# Product Change Notification

**Issue Date:** January 13, 2015

**Product Name:** RHD-302SATA-RS-R10

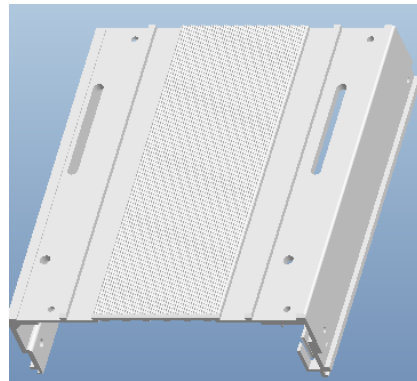
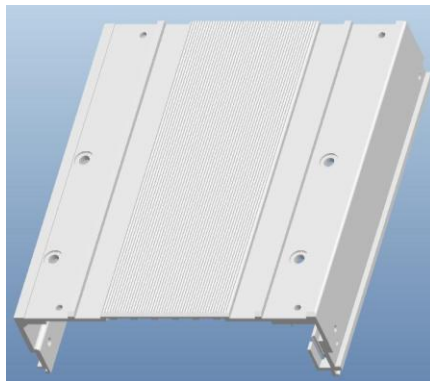
1. In order to increase the compatibility of 6TB 3.5" HDD installation, we modify the bottom cover by adding two ellipse holes also change the middle screw holes to ellipse.
2. In order to increase the compatibility of SAS and SATA SSD/HDD installation, we modify SATA connector by remove the bulkhead between power 15pin and data 7pin.

Change design from

to

to

Affected Model	New Version
RHD-302SATA-RS-R10	RHD-302SATA-RS-R11
